Agenda Item #5

Certified Record 2025-47-CA

360 Dauphin Street

Alterations to south facade

A3

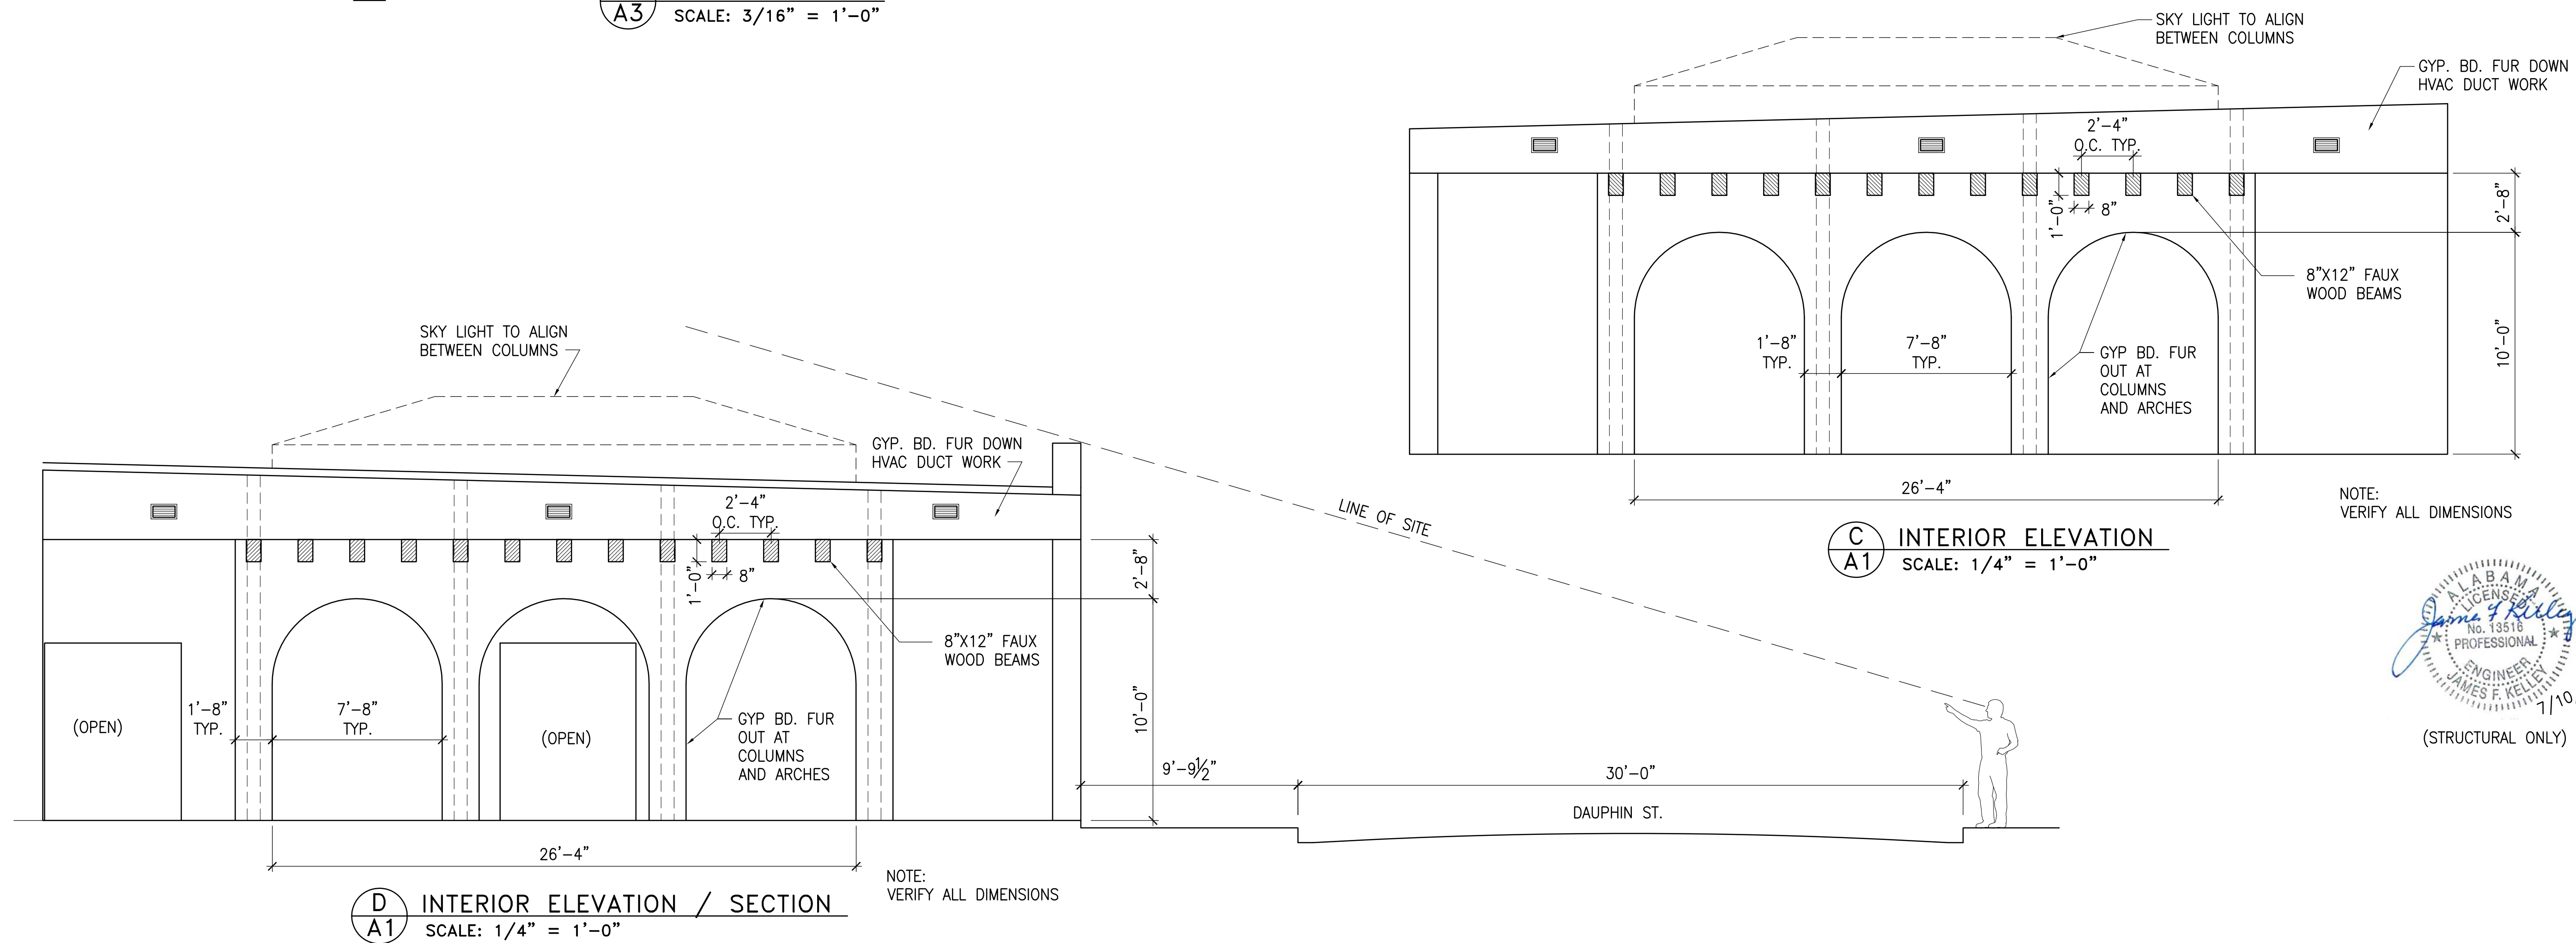
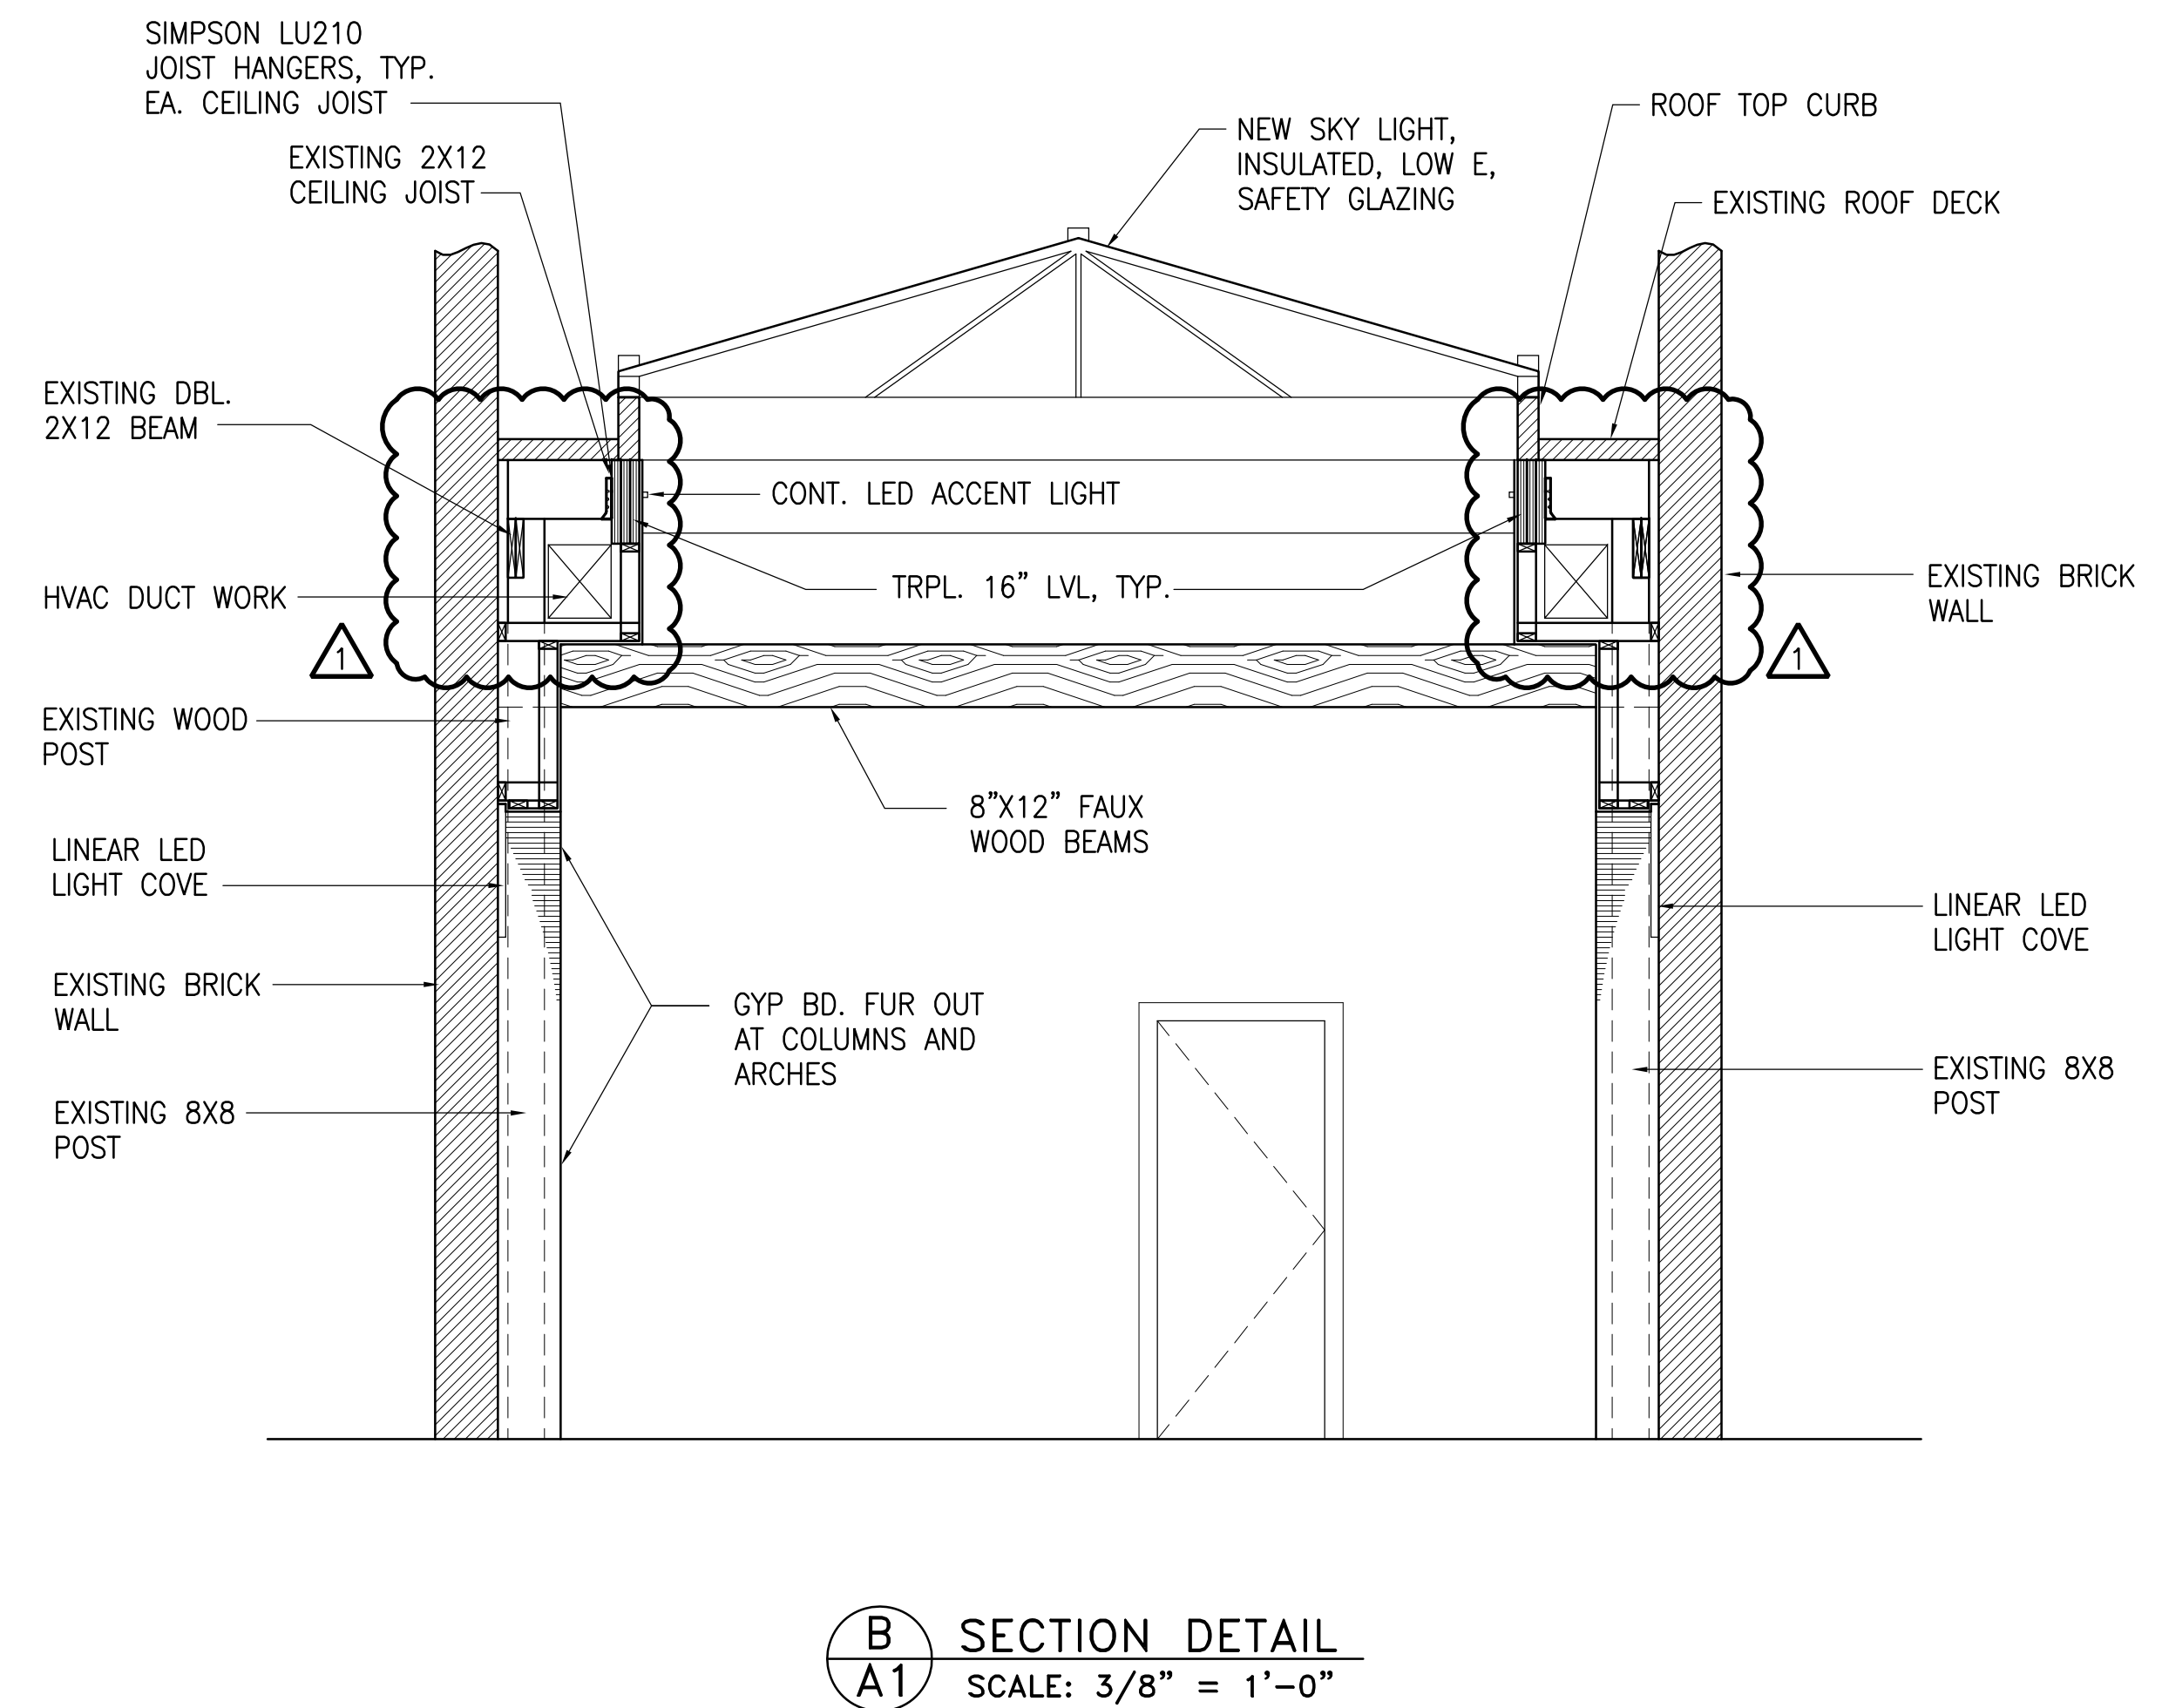
The proposed windows do lack an upper division to give the appearance of a transom. All other buildings on the block feature visible transoms above their storefront windows and/or entrance doors. Moreover, the Design Guidelines encourage including transoms in any new or replacement storefront design. A light divider across the top of the proposed windows roughly in line with the bottom of the transom glass at 362 Dauphin Street would blend better with the established fenestration pattern of the street. (7.18)

The application also proposes installing a low-e film on the windows. The Guidelines discourage the use of opaque window treatments, so any applied window films should maintain an appropriate level of transparency. (7.19)
